License to Operate On-Site Sewage Treatment and Disposal Facility

Issued This Date: 03/31/2023 Permit Number: 115540

Permit of Authorization to Construct an On-Site Sewage Facility Permit Valid For One Year From Date Issued

**AEROBIC TREATMENT
DRIP TUBING SYSTEM
FOR:
LOT 54, BLK. A
CANYON LAKE ESTATES, SECTION 1**

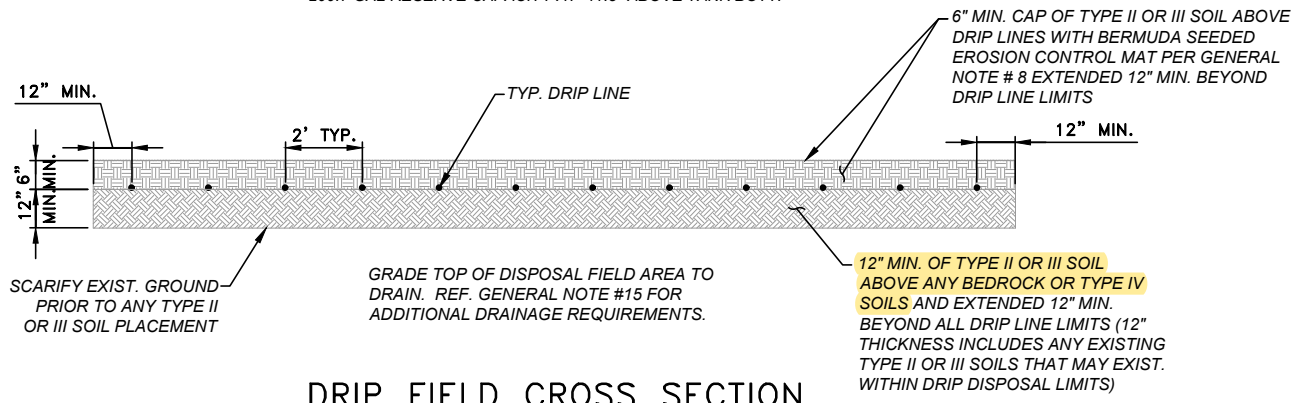
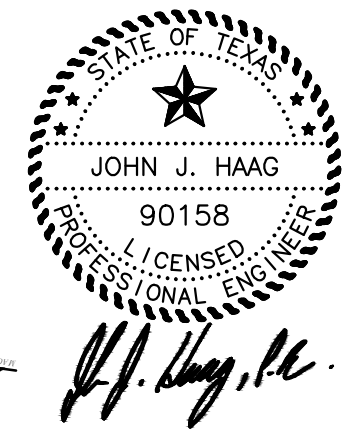
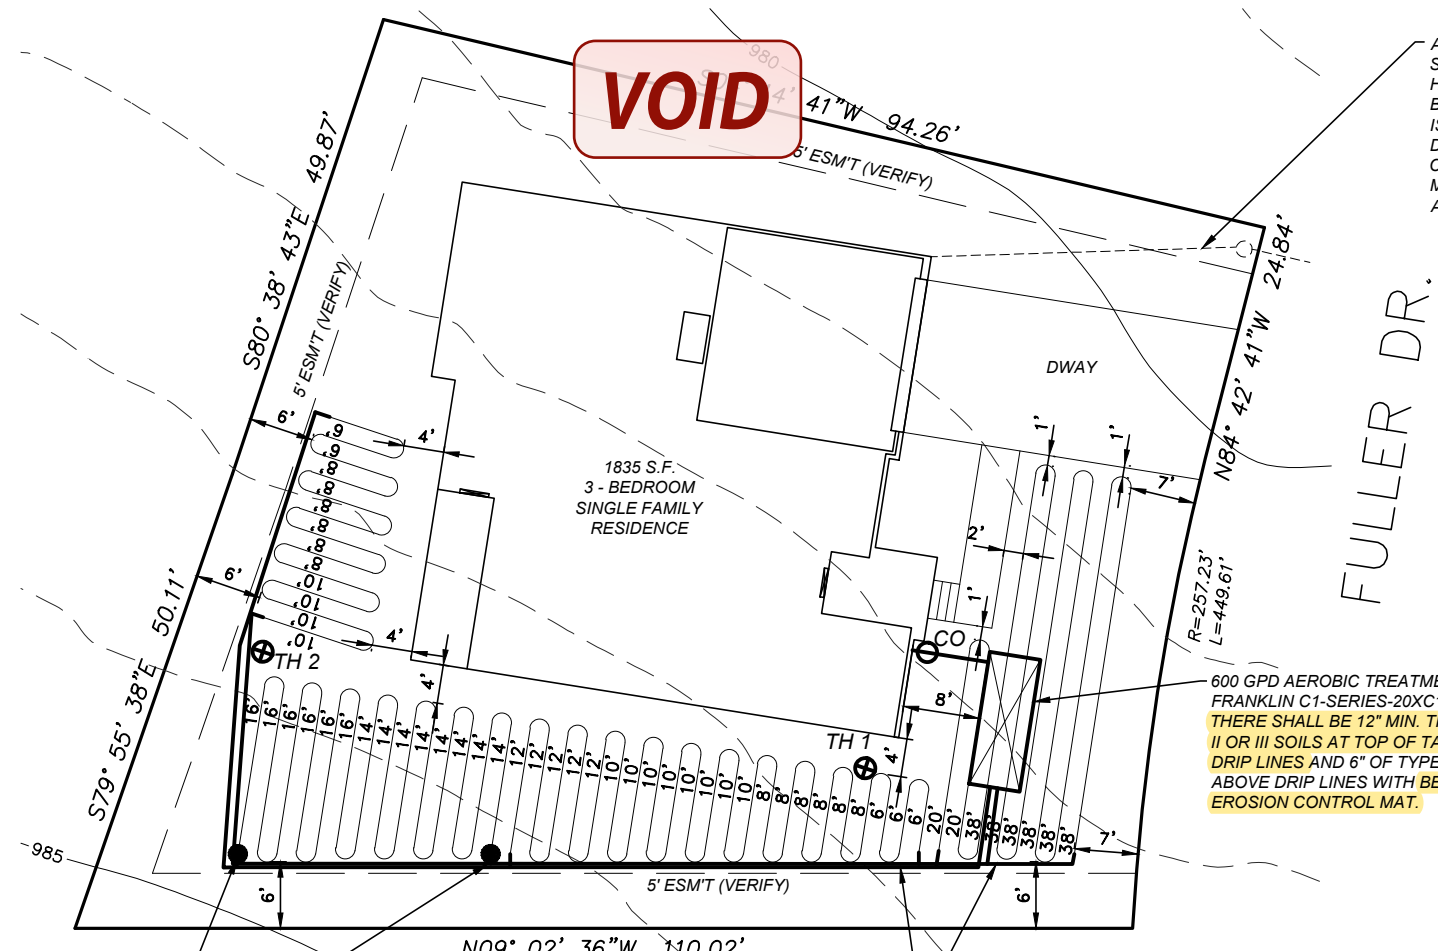
We received planning materials for the referenced permit application on 12-05-2022 and found those planning materials to be deficient. In order to continue processing this permit, we need the following:

1.  Submit the pump tank details showing the float settings and the reserve capacity
2. Revise accordingly and resubmit.

PUMP FLOAT SETTINGS FOR 240 GPD DAILY FLOW AND 80 GAL RESERVE:
 PUMP OFF POSITION: 12" ABOVE TANK BOTT. (221.2 GAL.)
 PUMP ON POSITION: 25" ABOVE TANK BOTT. (464.4 GAL.)
 ALARM ON POSITION: 31" ABOVE TANK BOTT. (577.9 GAL.)
 200.7 GAL RESERVE CAPACITY AT 41.5" ABOVE TANK BOTT.

REVISED
5:23 pm, Feb 23, 2023

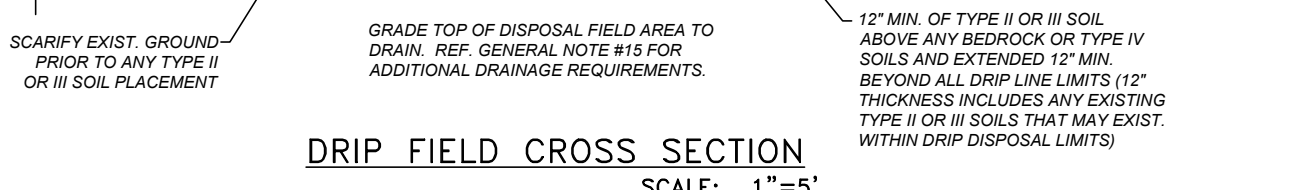
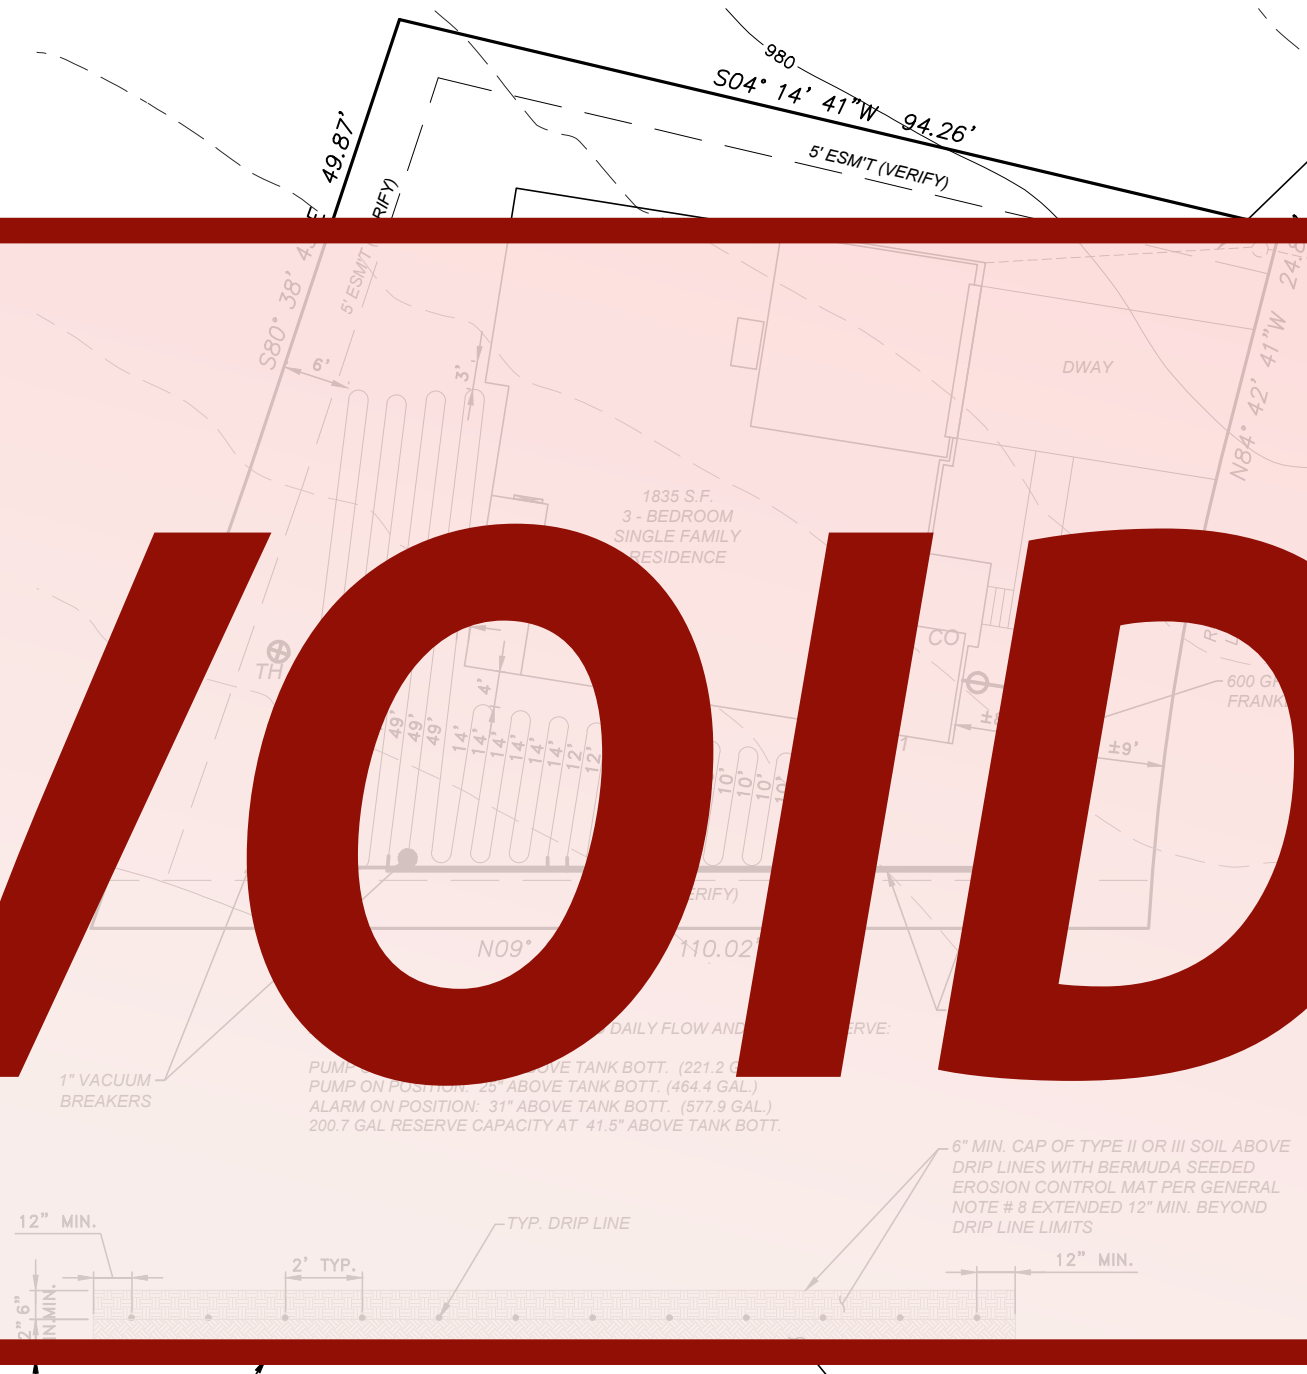
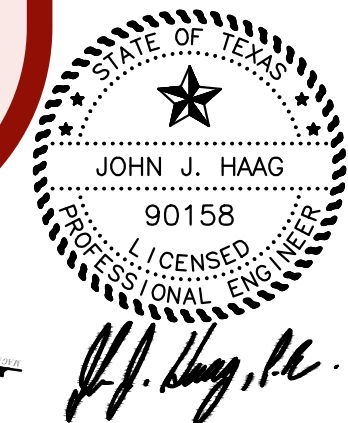
1. House location (changed because it wasn't located on lot per pre-construction architectural site layout plan);
2. Drip lines;
3. Tank location

THIS PLAN WAS REVISED ON 02/23/2023 TO REFLECT, AS MUCH AS POSSIBLE, AS-BUILT INFORMATION PROVIDED TO HAAG ENGINEERING CONSULTANTS BY THE SEPTIC SYSTEM INSTALLER. HAAG ENGINEERING CONSULTANTS HAVE NOT FIELD VERIFIED ANY SEPTIC SYSTEM AS-BUILT CONDITIONS FOR THIS PROJECT AND DOES NOT WARRANT TO ITS VALIDITY AND/OR ACCURACY.
